**George Town Harbour – Repair of an Existing Seawall
Block: OPY Parcel: 18**

Authored by: Technical Review Committee - Department of Environment, on behalf of the Director,
Department of Environment

Coastal Works Review

FIGURE 1: DOE SITE VISIT PHOTOS SHOWING THE DAMAGED SEAWALL (2021)

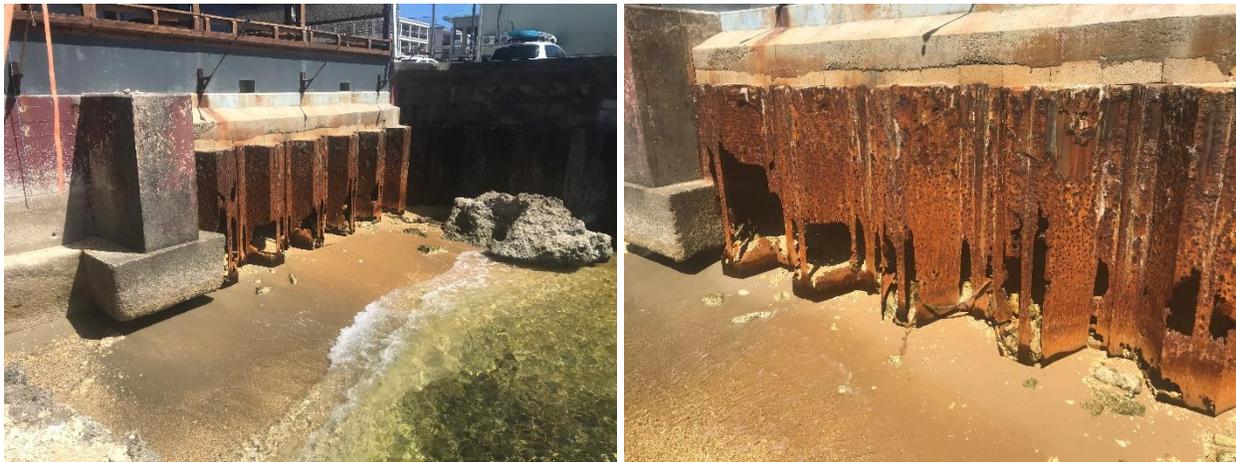
The applicant-Little Liquor Store Ltd.- is seeking permission for the repair of an existing seawall in order to secure the existing structure that is being undermined by corrosion and impact from the sea, as shown in Figures 1 and 2.
